BOLTON PLANNING & ZONING COMMISSION
Regular Meeting
7:30 p.m., Wednesday, March 2, 2022
Virtual Meeting
Minutes & Motions

3. Public Hearings (begin at 7:45 p.m.)
a. Special Permit Application for Gas Station/Convenience Store, 271 Hop River Road, Nathan Fleming (#PL-22-2)

Detail Sheet
of
271 Hop River Road
Bolton, Connecticut
Prepared For:
IMS PETROLEUM, LLC
January 3, 2022

SHEET NO. 3 OF 5 JOB NO. 21-000985 DRAWN BY: CAC

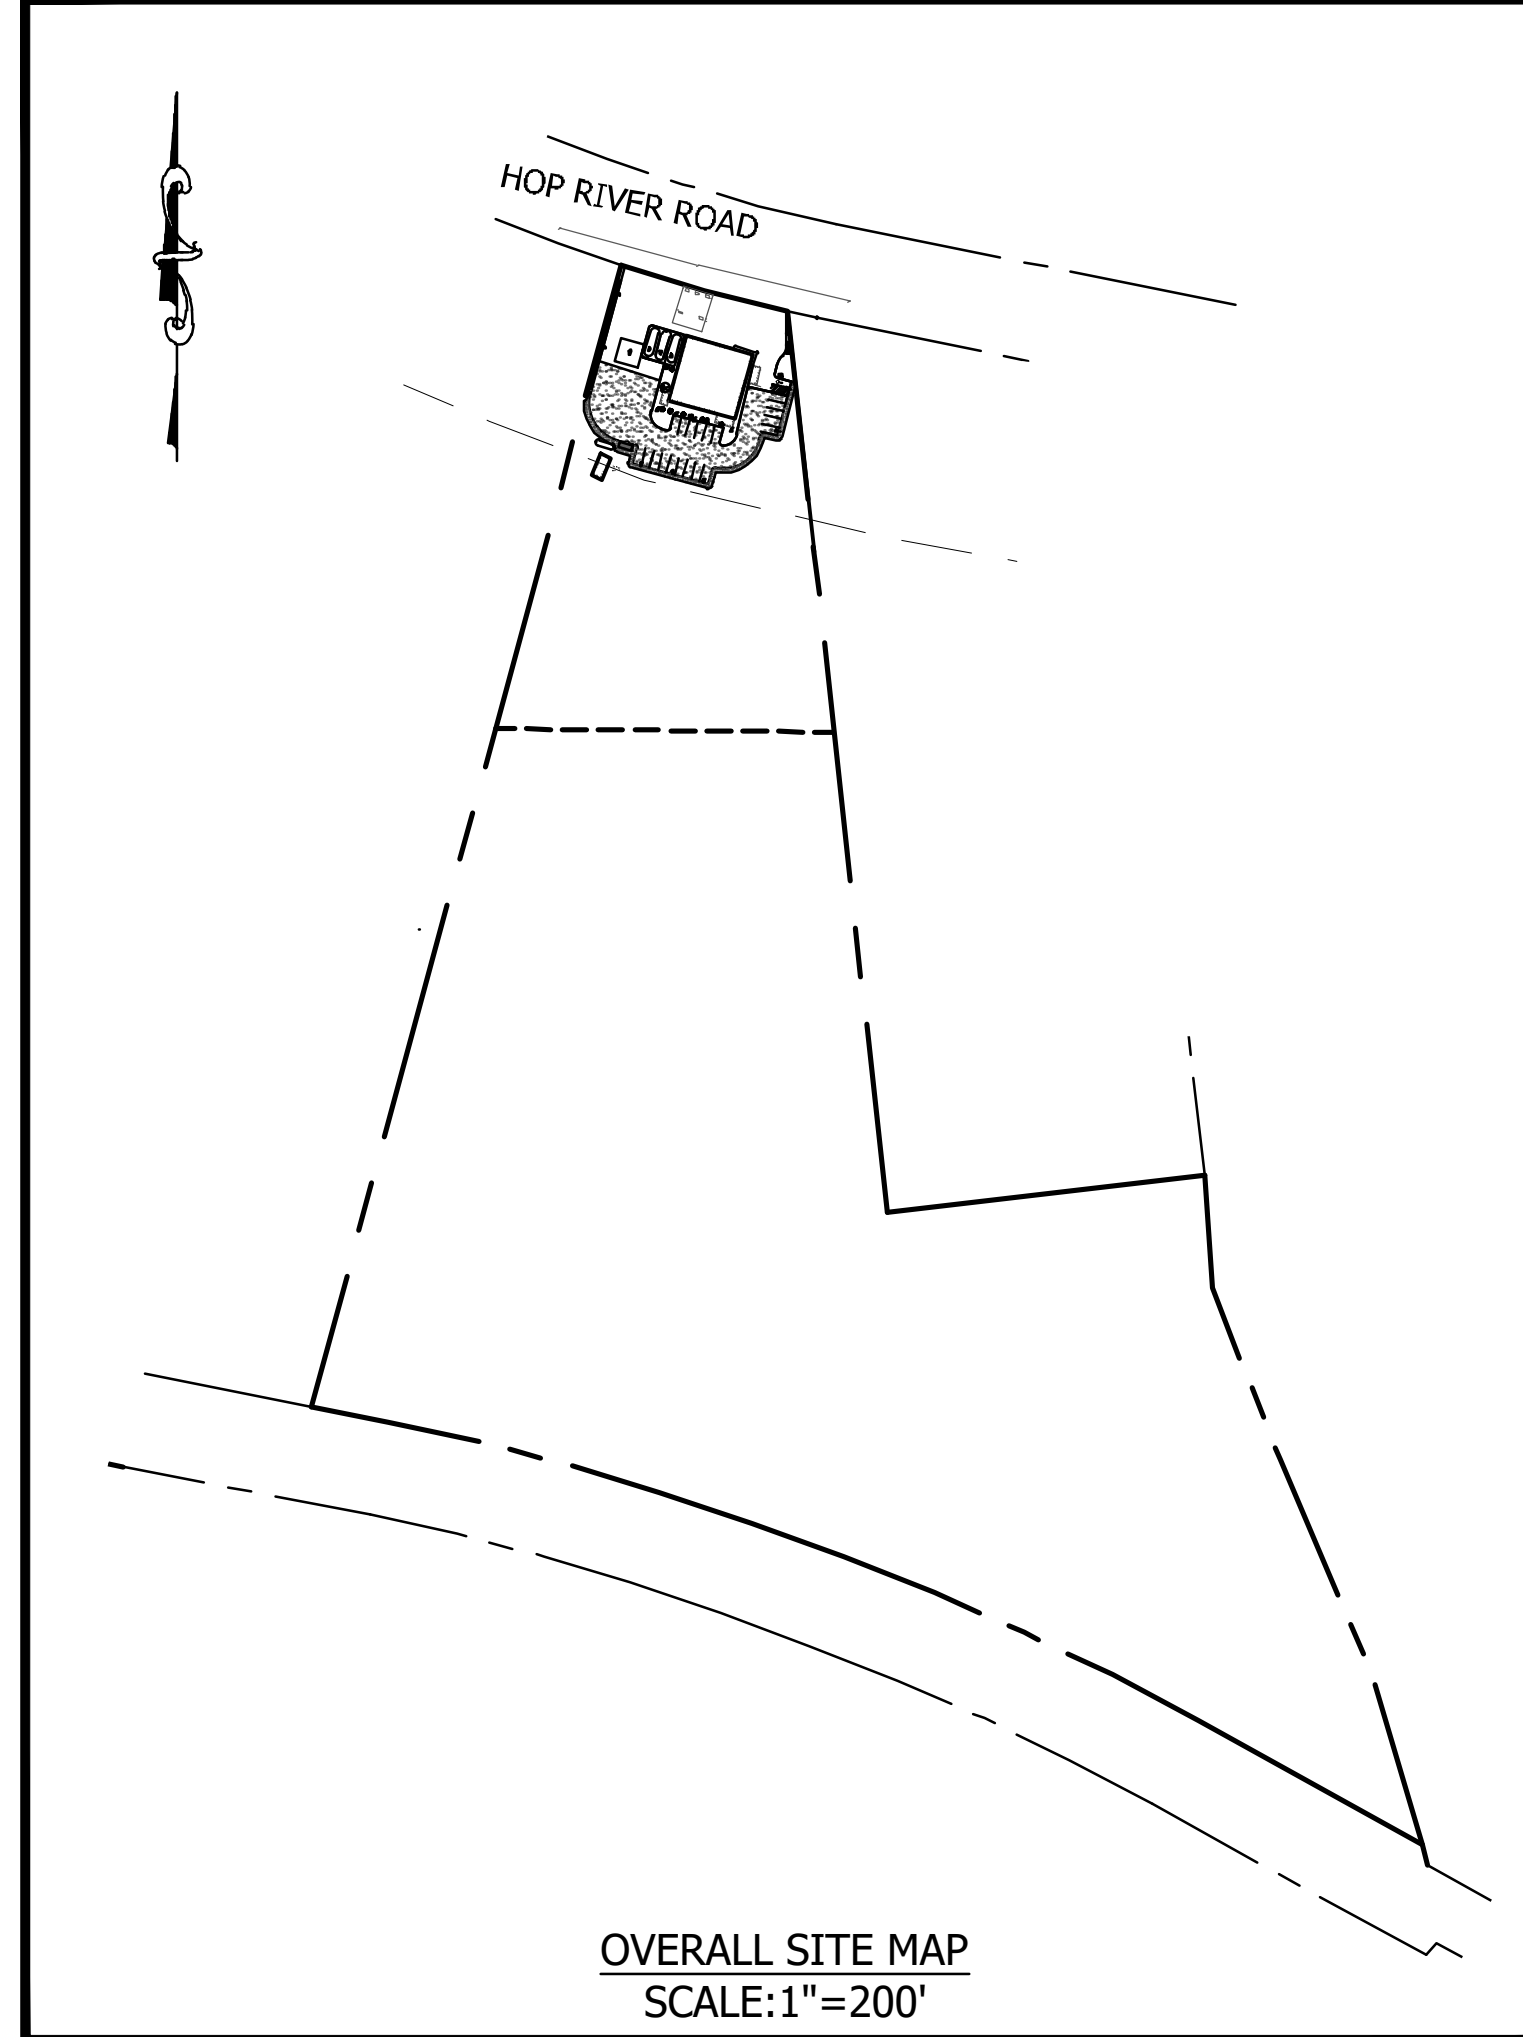
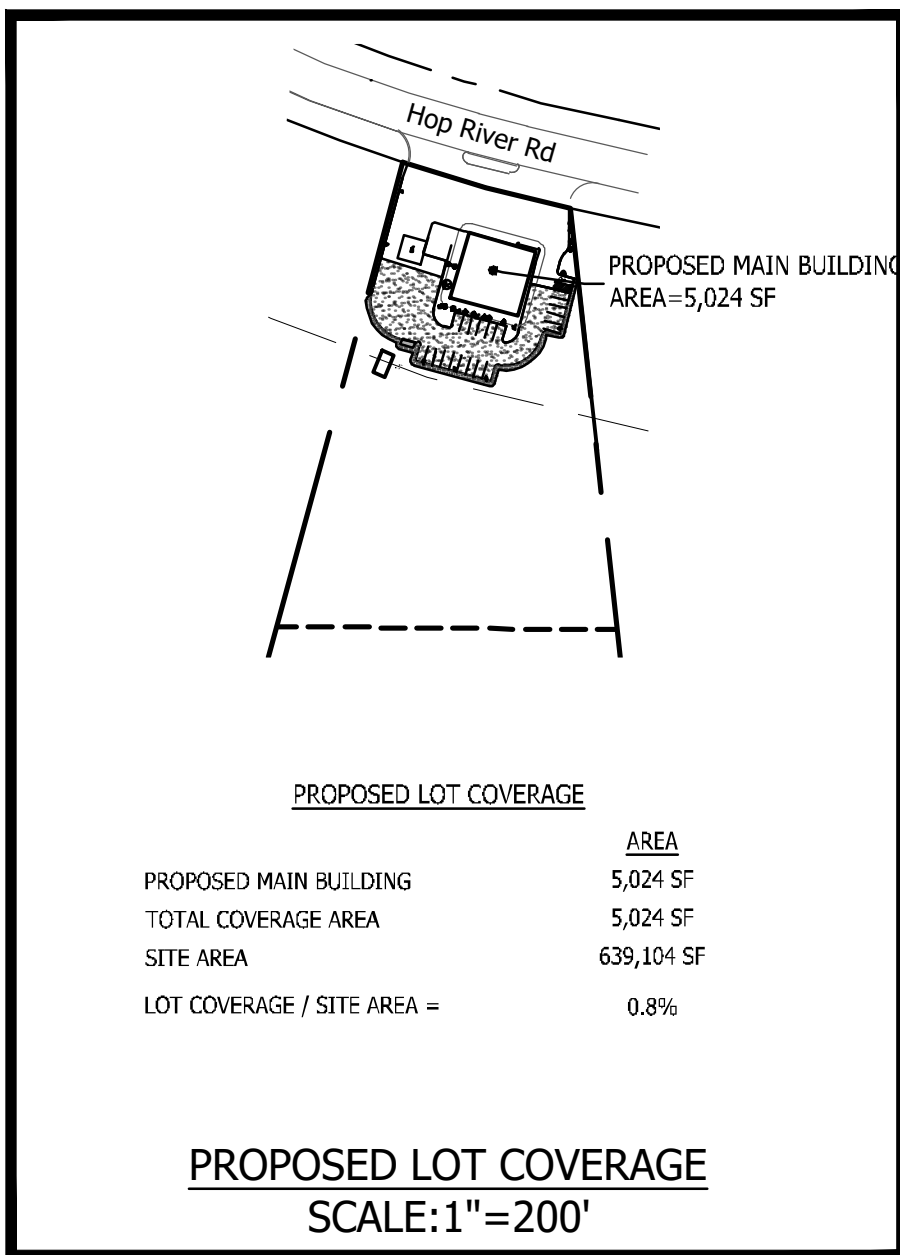
3. A Landscaping Plan in accordance with Section 16A.3.g of the Town of Bolton Zoning Regulations should be provided. – **Landscaping plan added sheet 3 of 5.**

4. A Lighting Plan in accordance with Section 16A.3j of the Town of Bolton Zoning Regulations should be provided. – **Lighting Plan added sheet 3 of 5.**
